# TAG FARNBOROUGH AIRPORT AIRSPACE CHANGE PROPOSAL

CAP 1678

5. The CAA does not approve the proposal to change airspace design wholly in the form proposed by the Sponsor set out in the documents listed below. However, in accordance with Direction 5(2) of the CAA Air Navigation Directions 2017, the CAA may make its approval of a proposal subject to such modifications and conditions as the CAA considers necessary. On the basis that the Sponsor will give the undertakings set out in Annexe A, the CAA has decided to approve the ACP with the modifications described in Appendix B – Figure 4. The CAA will allow the Sponsor a short period of time in which to decide whether it would rather withdraw its proposal than implement the ACP as modified which the CAA approves. The proposal as modified (“the Modified ACP”) is:

Figure 4 - Option 38 with Class E + TMZ Farnborough proposals with revisions for the purpose of the draft decision

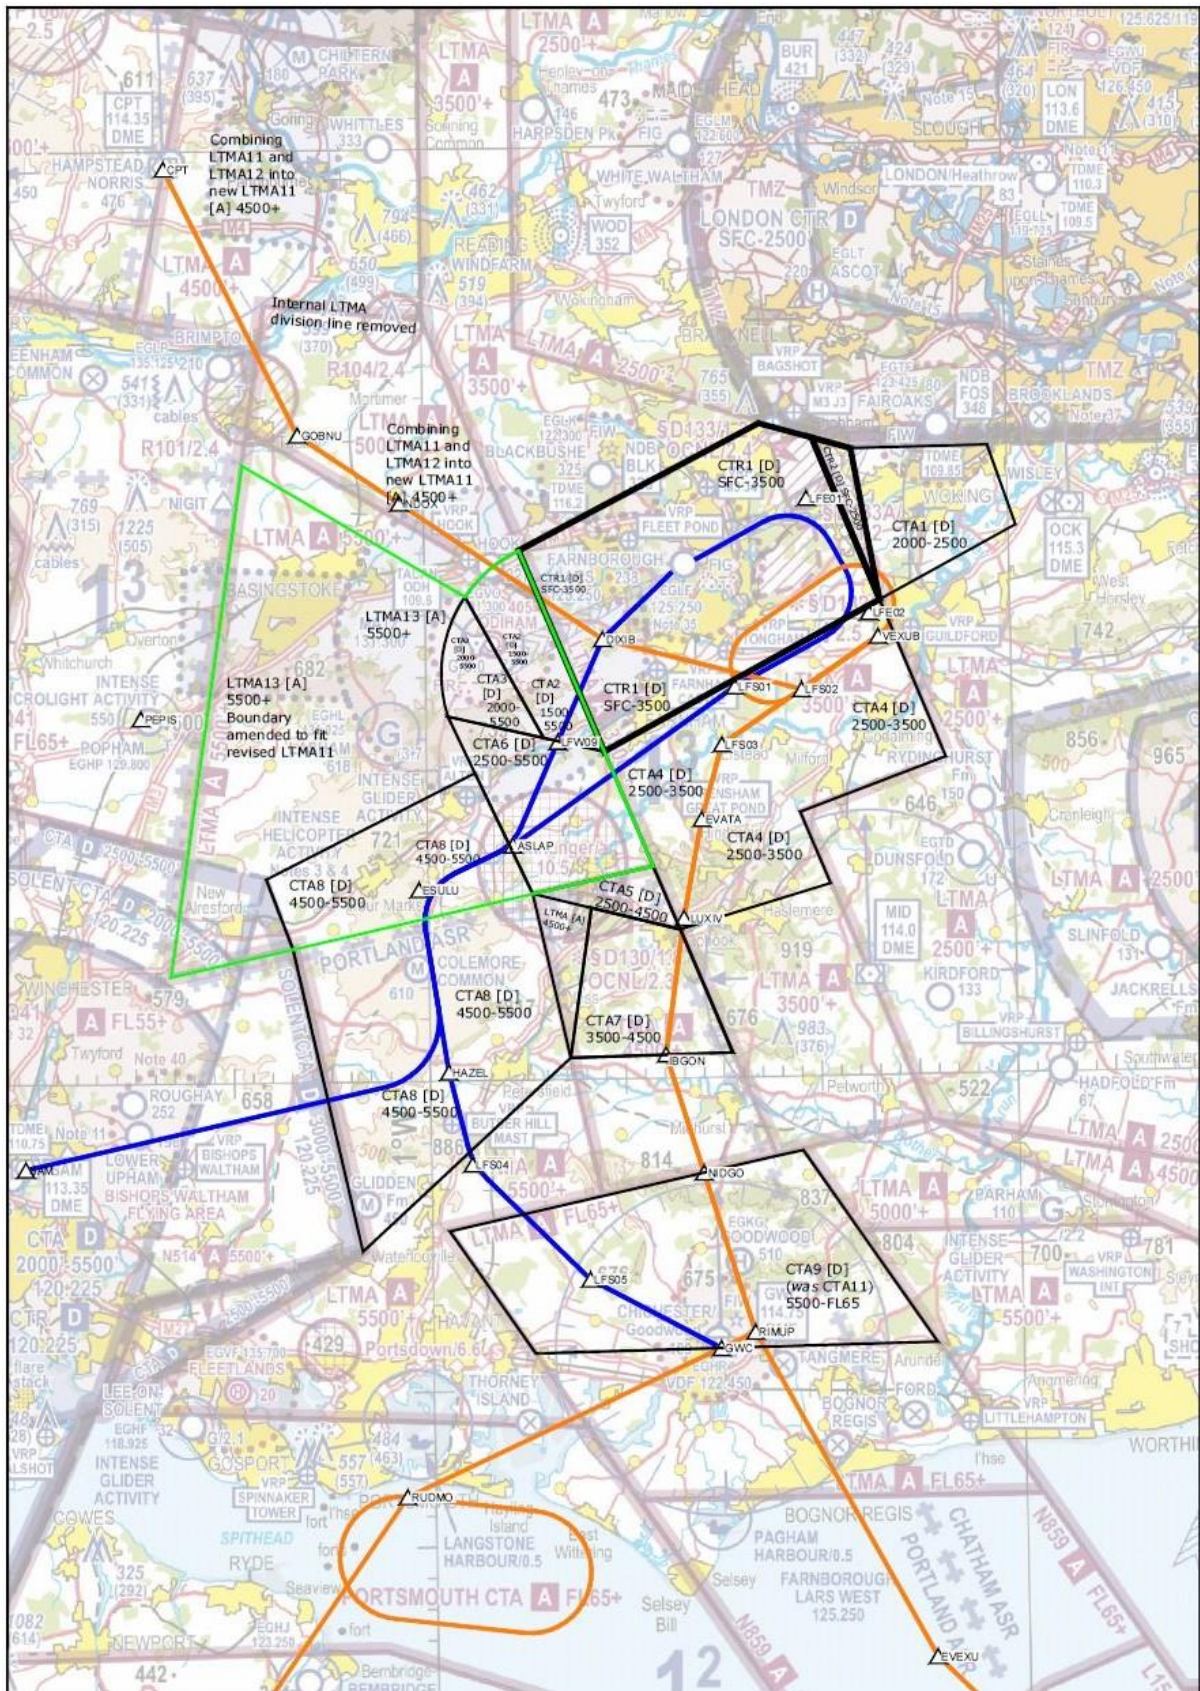
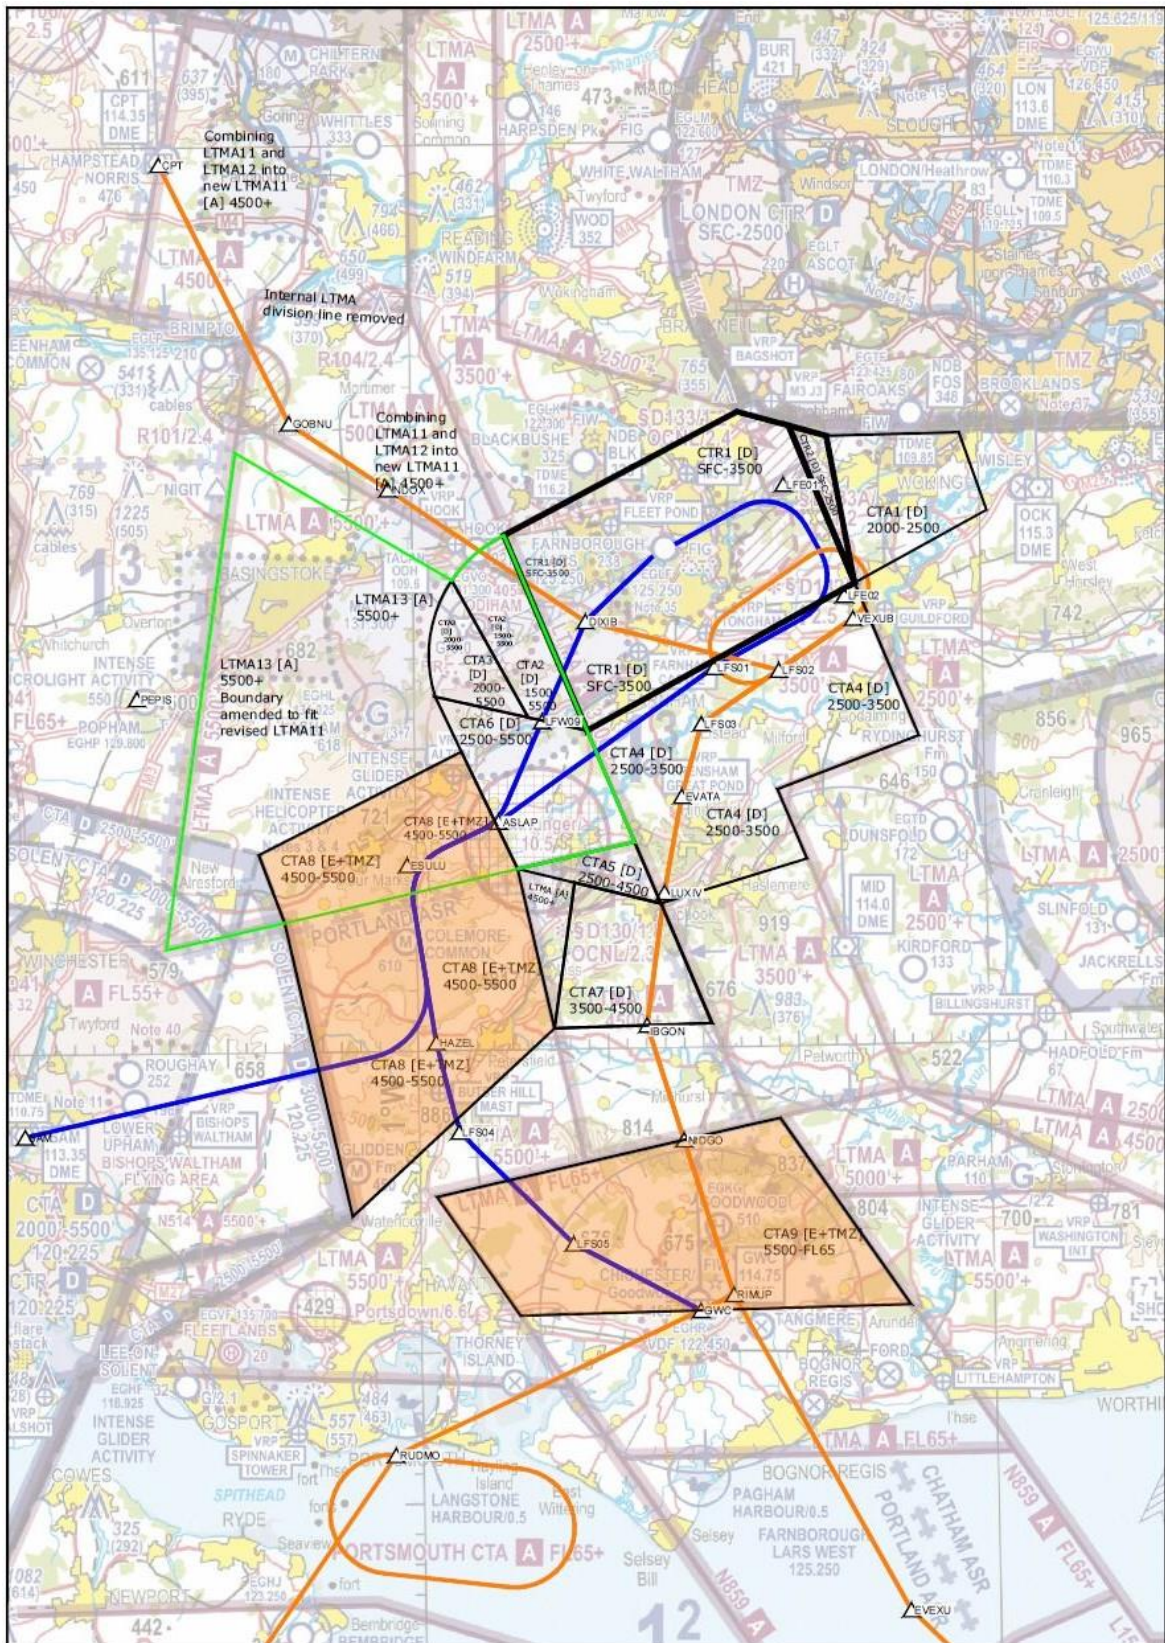
11. The CAA requires the Sponsor to advise the CAA whether it wishes to proceed to implement the Modified ACP approved by the CAA or to withdraw its proposal by 18 July 2018. The modifications are presented in Appendix B – Figure 4. We will publish the Sponsor's response in this regard on our website.

## Description of revisions between Figure 3 (above) and Figure 4 (below)

- A Class D control zone (CTR) and Class D and Class E+ transponder mandatory zone (TMZ) control areas (CTAs).
- 
- The combination of Class A controlled airspace (CAS) LTMA 11 and LTMA 12 into a revised LTMA 11 with a base altitude 4500 feet and extend the southerly boundary of the revised LTMA 11 by one mile
- Within the CTR and CTAs, RNAV1 SIDs and STARs.
- 
- New initial approach procedures (IAPs) at the end of the STAR to connect the en-route phase of flight to the final approach to the runway.

Figure 3.2B

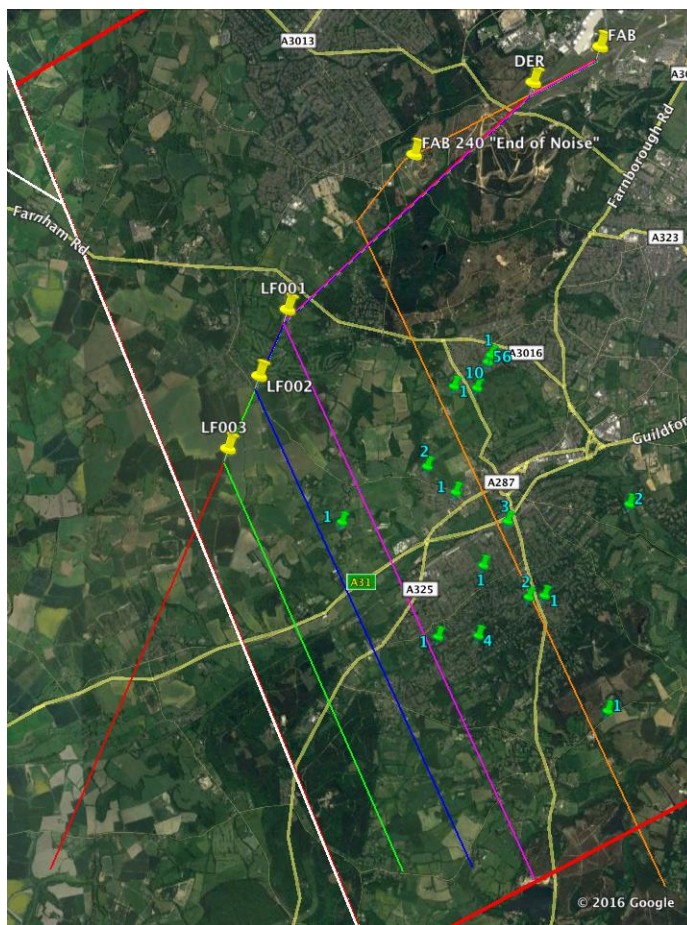
Our Option 1 route is also represented by the magenta line from LF001 in Figure 3.2B below. Analysis of Rushmoor Council’s historical data reveals that this has attracted 6 noise complaints in 6 years. It therefore appears that this route is acceptable and viable.

Nevertheless, this we have considered two further routes via LF0002 and LF003, shown in Figure 3.2B, which have attracted one and no complaints respectively, but are closer to the edge of CAS, at 1.5 nm and 0.5 nm, in turn. These are NPRs and not SIDs and so for the purposes of CAP 778 require no CAS at all. So whilst they do not “replicate” the lateral distance criterion to the edge of CAS as stated in the CAA’s Containment Policy, they are still enclosed within CAS.

- Option 1, which routes via LF001 (magenta), overflies 4000-4500 houses,
- Option 2, which routes via LF002 (blue), overflies 2510-2560 houses,
- An additional routing that was considered, which has not been pursued further, via LF003 (green), overflies 1650-1700 houses,
- TAG’s proposal (red) overflies 1650-1700 houses.

It can therefore be concluded that both the green and TAG’s route are environmentally equivalent in this respect, that the blue Option 2 route is nearly as effective and that Option 2 is environmentally better than Option 1.

## RESPONSE TO DOCUMENT SENT TO THE SOUTHDOWN GLIDING CLUB BY [REDACTED] ON 14TH DECEMBER 2016

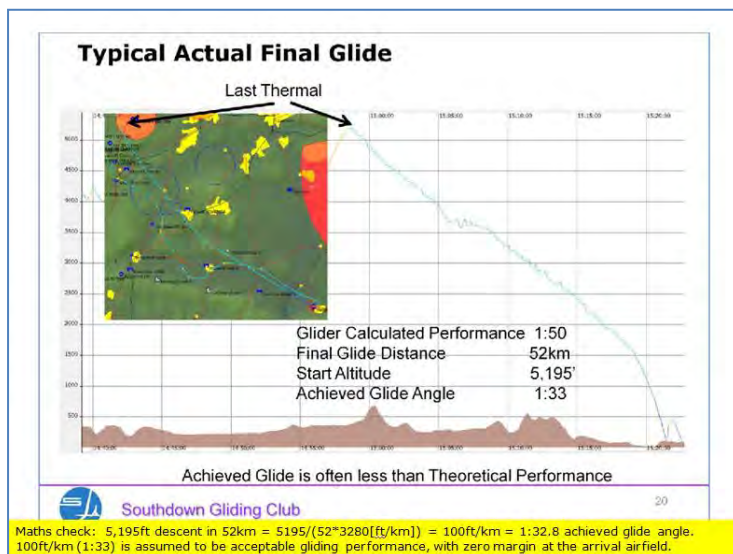
The plan view that was requested and was sent by [REDACTED] on the 14th December, forms parts of Option 39 and is consistent with the December 2016 Airspace change submission to the CAA by TAG.

In the letter sent by [REDACTED], he seems to claim that a very minor change to the Option 36 design will make it possible for Southdown Gliders to return home after inland cross-countries.

## 2. SGC Observations regarding the Option 39 design.

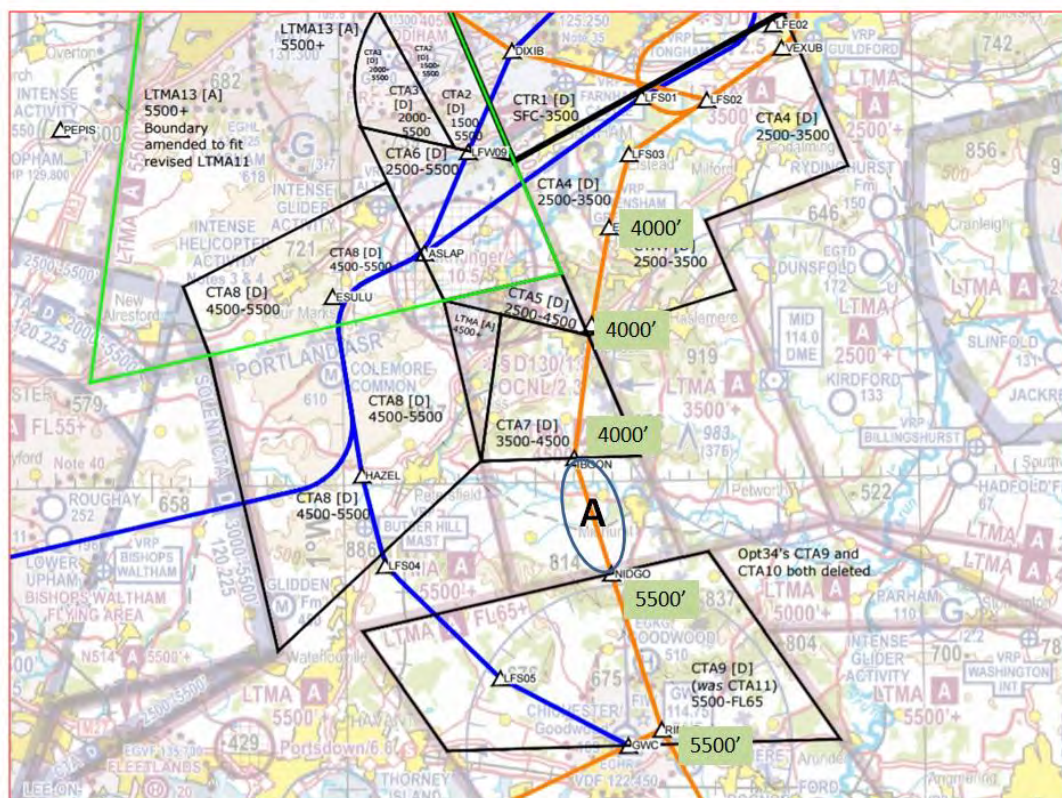
- The design creates large areas low altitude airspace underneath existing LTMA which forces arrivals from the south to descend *much earlier* than normal and fly very inefficient paths not consistent with CDO or CAA FAS.
- Noise levels on the ground will be much higher than occur during typical arrivals over the last decade which are much higher and ARE consistent with CDO & FAS
- TAG have expressed their desire to have their 'OWN' airspace to avoid the need to liaise with Gatwick, however, arrivals from the South are unable to transit from NIDGO to IBGON **without first liaising with Gatwick** as aircraft must **pass through Gatwick Departures** in the area labelled **A** in the above chart.
- Once the precedent of necessary liaison with Gatwick to penetrate the Gatwick departures is established, this gives opportunities for a much better and less disruptive airspace design.
